APPLICATION NO.	FILING DATE	FIRST NAMED INVENTOR	ATTORNEY DOCKET NO.	CONFIRMATION NO.
10/693,529	10/24/2003	Robert Johnston	RIVER-001XX	2299
28452	7590	01/25/2006		
BOURQUE & ASSOCIATES, P.A. 835 HANOVER STREET SUITE 303 MANCHESTER, NH 03104			EXAMINER LARSON, JUSTIN MATTHEW	
			ART UNIT 3727	PAPER NUMBER

Office Action Summary

DETAILED ACTION

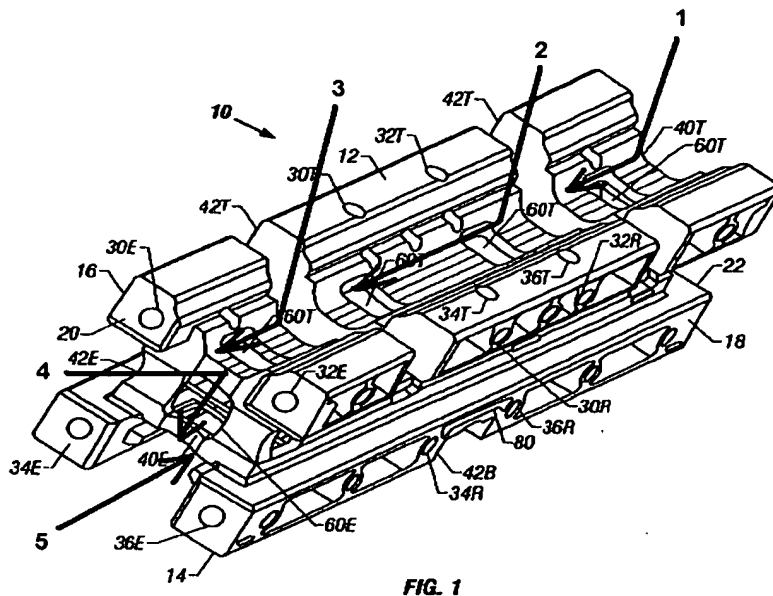
Regarding claim 1, Szigeti discloses a carrier comprising a body of resilient material, said body including: a bottom surface and a top surface, the top surface including a plurality of raised protrusions defining a support surface, said plurality of protrusions also defining a first and at least second support channel (1 & 2, respectively, below) disposed substantially transverse to said support surface.

Regarding claims 2, the carrier of Szigeti further has a third and at least a fourth support channel (3 & 4, respectively, above) on a first and at least second side of the body.
